**RE: PROPOSED RECONFIGURING A LOT
AT 174 DOWDING STREET IN OXLEY
COUNCIL REFERENCE NUMBER A006653092**

We refer to the above application, Councils Further Issues letter dated 8 October 2025 and our subsequent discussions. Please find below a response to the items raised in these requests:

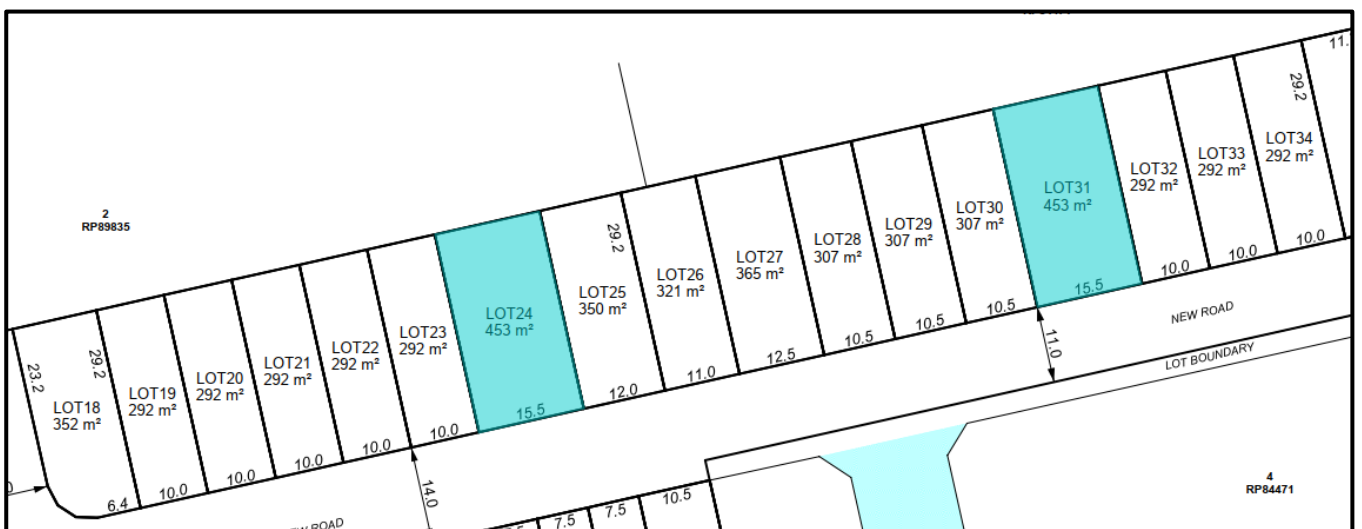
In response to item 1 of Council's request, we confirm that the proposed layout has been amended to break up lots 18 to 34, as requested.

Please refer to the image below for confirmation of this change.

Note that proposed lots 24 and 31 (shaded in aqua) now exceed 450m² in area

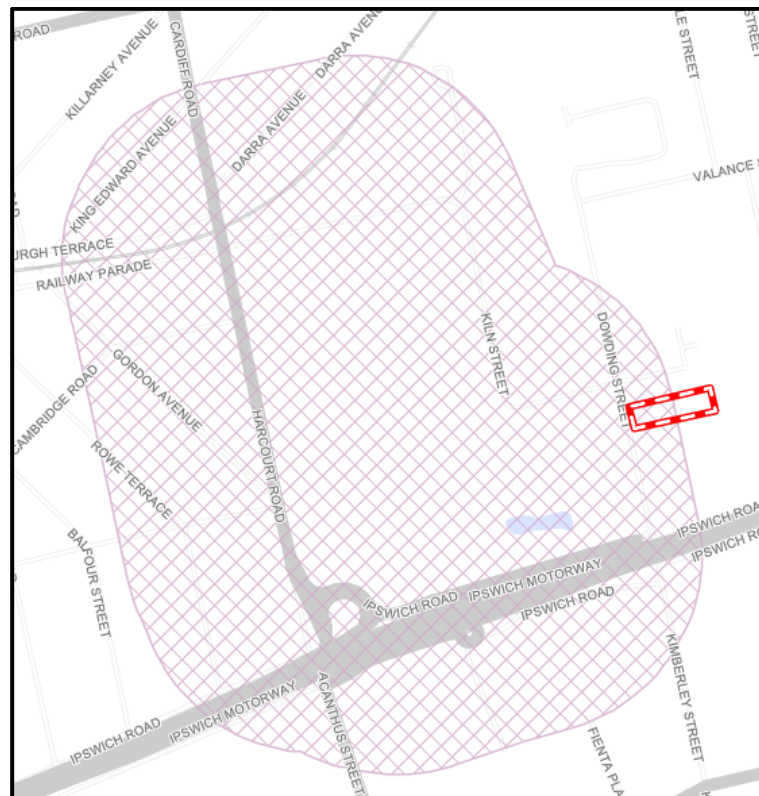
In response to items 2 and 3 of Councils request, we confirm that the proposal has been redesigned to enlarge the basin size and to reorientate lots 6 and 7 towards Dowding Street.

- The project engineer has confirmed that the proposed discharge to Dowding street is significantly less than the pre development area and therefore meets Brisbane City Council Planning Scheme Policy - Infrastructure Works - Chapter 7 planning provisions.

- Additionally, the location of these two allotments aligns with the existing residential development directly to the South and would be seen as a continuation of the existing residential uses (190-198 Dowding Street). Allowing these allotments to front Dowding street alleviates the complexity of the servicing of these lots and restricts the length of the access/services easement proposed in the previous iteration of the Civil design. All services are readily available on Dowding Street to service these allotments.

- The proximity of the proposed allotments to the existing Greenview intersection is greater than 100m. Based on the posted speed limit, availability of the road shoulder, the required vehicular accesses should not impede the performance of the intersection.

- The predevelopment access solution to Dowding street consisted of 4 individual driveway crossover accesses. While the current proposal reduces that down to two.

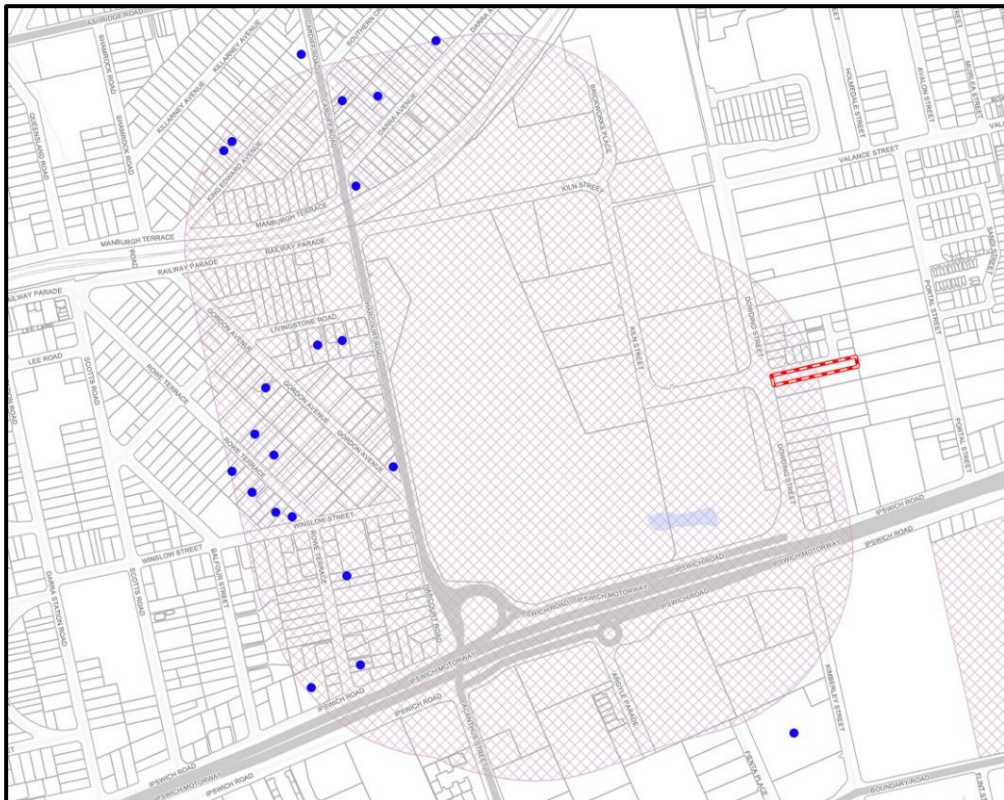
- Further investigations on our side determined that the acoustic fencing was no longer required to Dowding Street in this instance, as the mapping is out of date. More specifically, we note Council's request related to the industrial amenity overlay mapping on the site at 99 Harcourt Road in Darra. A site which was previously used as a quarry and brickworks factory, but has since been redeveloped. Refer to <https://decc.com.au/projects/csr-darra-remediation/> which details the site remediation works undertaken. Given the fence was no longer required, it has been removed to facilitate the servicing design changes described above.

Purple hatching = Industrial amenity overlay mapping

Blue circle = Former quarry/brickworks site.

The absence of a “need” for the fence is also supported by the recent surrounding developments. Noting that a review of the subdivision approvals below (which are covered by the same overlay) has confirmed that they did not require the installation of acoustic fencing.

Blue dots – Approved residential development which didn't require acoustic fencing

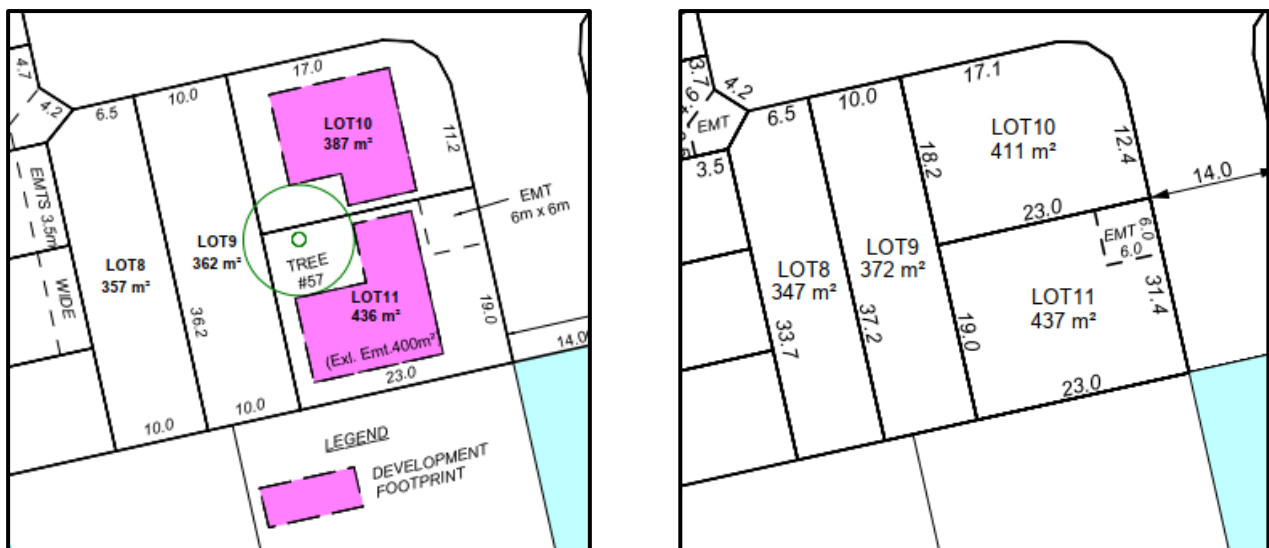
In response to Council's request and the design changes detailed in the previous heading, we confirm that the proposed refuse turn around has been relocated from the frontage of lots 1 and 2, to the easement in lot 4. The pedestrian connection has also been relocated to the south, to sit between lots 3 and 4.

Please refer to the before and after images below for confirmation of these changes.
